Technical Service Bulletin

25-EM-007H

**ITM THERMOSTAT SPRING INSTALLATION &
ECU SOFTWARE UPDATE – DTC P218100**

Description: Some Elantra (CN7, CN7A), Kona (OS, SX2), and Sonata Hybrid (DN8 HEV) vehicles equipped with 2.0L engines may illuminate a warning lamp for DTC P218100 (Cooling System Performance) related to the Integrated Thermal-Management Module (ITM).

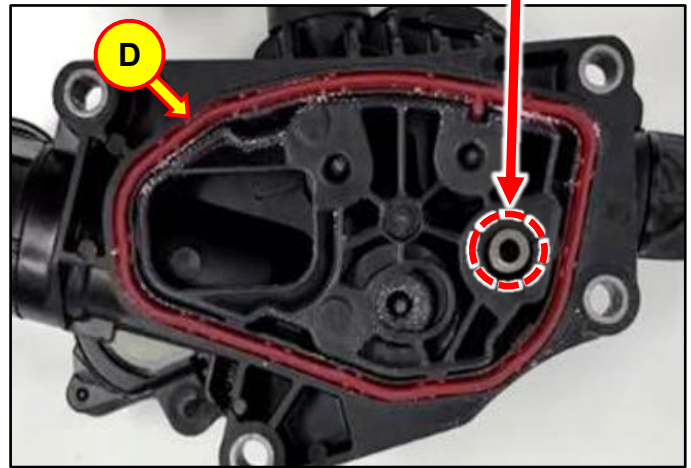
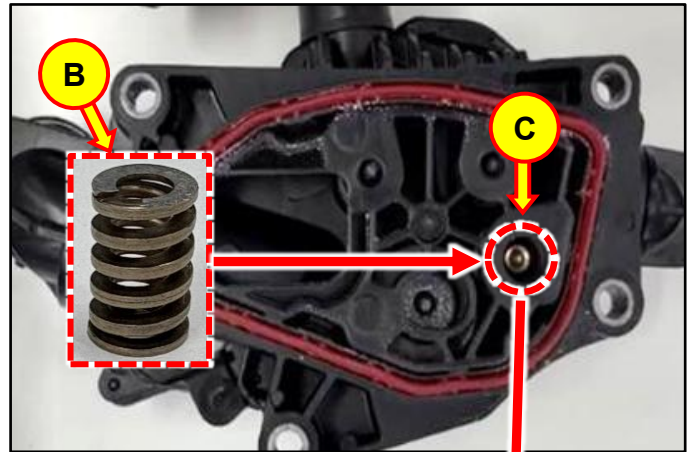
2. Insert the spring (B) into the ITM thermostat hole (C).
3. Install the new thermostat housing gasket (D) onto the ITM.

Ensure that the gasket is properly installed and pushed into the grooves of the ITM housing.

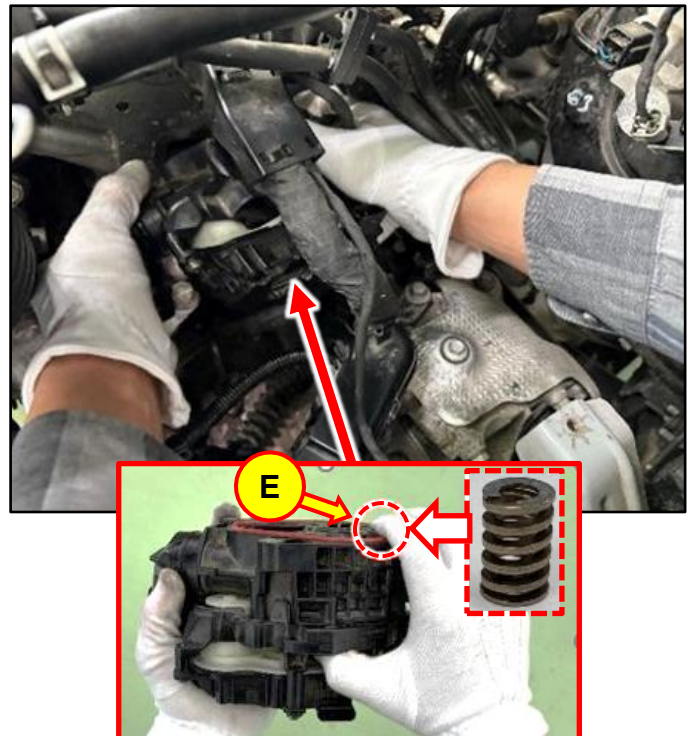
When installing the ITM assembly, hold the spring down with your finger as shown (E) to prevent the spring from falling out.
